Staff Report & Recommendation

Historic Preservation Board

SUBJECT: HPB20-0387, **334 Ocean Drive.**

An application has been filed requesting a Certificate of Appropriateness for design modifications to the lobby and to the east façade of the building, including the introduction of a new canopy structure and variances from the minimum hotel unit size required and from the front and side setbacks.

334 Ocean Drive, east elevation, permit no. 15724

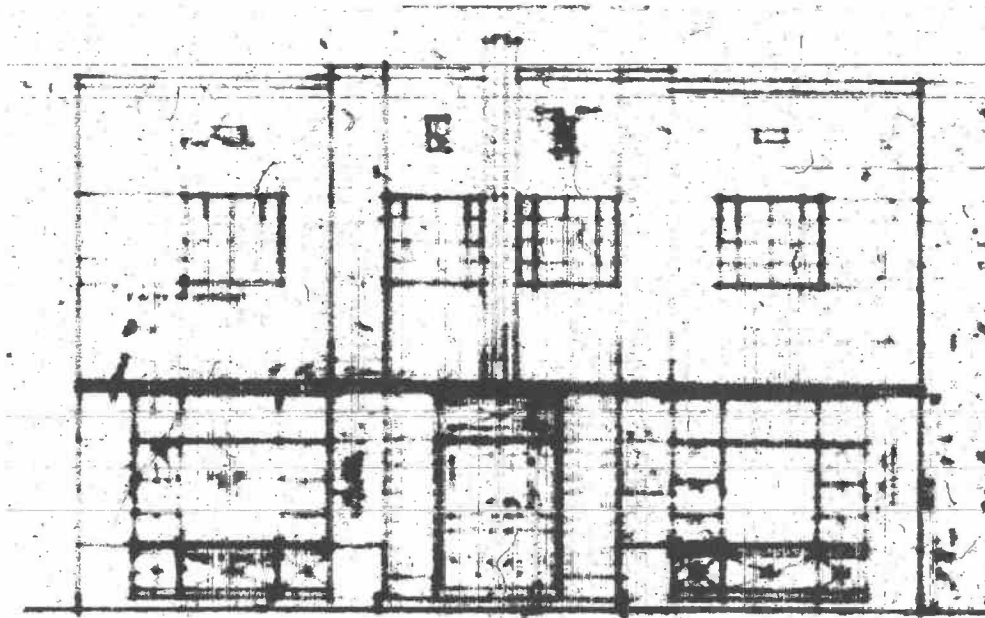
Along the primary (Ocean Drive) facade, the applicant is proposing to remove the existing approximately 18" continuous concrete eyebrow and attached metal awning to be replaced by a new canopy structure. The new bronze color canopy is attached to the building in the same location as the concrete eyebrow and extends approximately 5'-0" to the front property line. The canopy is supported by four sets of three metal columns that attach to the existing porch railing.

While having no objection to the introduction of a new canopy at this location, staff is concerned with the proposed demolition of the eyebrow feature, which is an original architectural element. As such, staff recommends that the eyebrow be retained and incorporated into the new canopy structure. Additionally, staff recommends that the color of the canopy be consistent with metal finishes of the Art Deco era including clear anodized aluminum, silver or mid to light bronze. Finally, staff recommends that any proposed lighting fixtures, fans, sprinkler pipes etc. that are attached to the canopy be fully integrated into the structure with no exposed conduit or piping.

- b. The preserved moss shall not be permitted to be installed on the Ocean Drive facade.
 - c. The existing continuous eyebrow structure shall be retained or reconstructed. Any new canopy structure shall integrate the eyebrow, in a manner to be reviewed and approved by staff consistent with the Certificate of Appropriateness Criteria and/or the directions from the Board. The finish of the new canopy shall be clear anodized aluminum or powder coated grey, silver or light bronze.
